Proposal #32: 6999-16-73, WISC 2024257
C Mosinee, Main Street
4th Street to Rangeline Road
Main Street
Marathon County

This is Addendum No. 02, which provides for the following:

ADDENDUM NO. 02

SPOT CURB AND GUTTER REPLACEMENT DETAIL

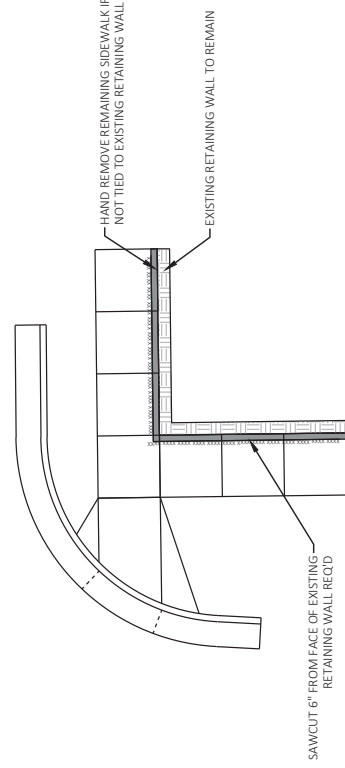
Revised Plan Sheets	
Plan Sheet	Plan Sheet Title (brief description of changes to sheet)
8	Construction Details (Spot Curb and Gutter Replacement)
45	Miscellaneous Quantities (Removing Pavement Items & Base Aggregate Dense Items)

NOTES:
REPLACE REMOVED ASPHALTIC MATERIAL
WITH BASE AGGREGATE DENSE 1 1/4-INCH
PRIOR TO PULVERIZING.
